PRODUCT CHANGE NOTIFICATION

Ref Nr: EBR-0176-22070801

To eliminate Laser marking of Shunt resistor PU3921—implementation date: Feb 8th, 2023

SHUNT RESISTOR AUTOMOTIVE GRADE

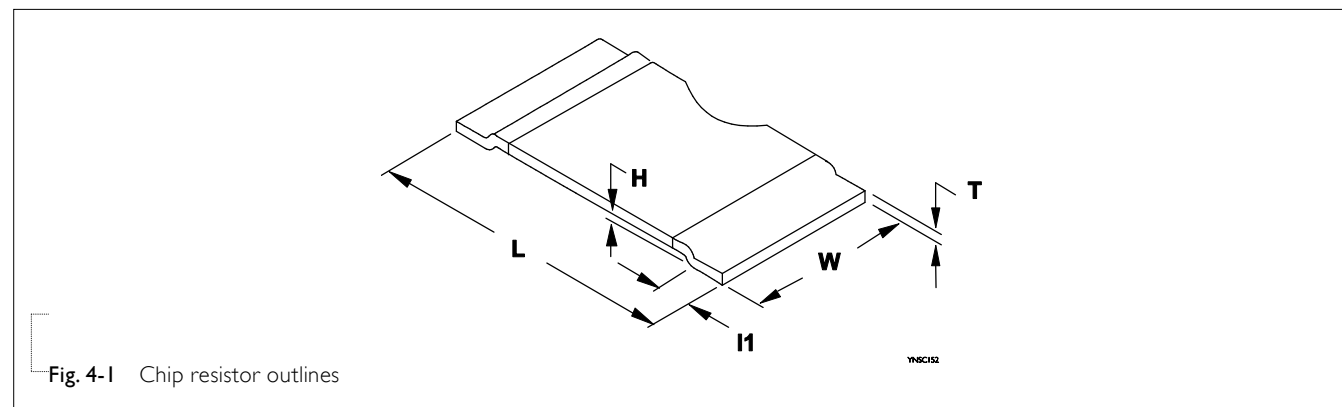
NOTE: There will be a short period of time that both types of PU3921, with marking and without marking, exist simultaneously in the market.
The exterior of PU3921 without marking is shown in Fig. 1
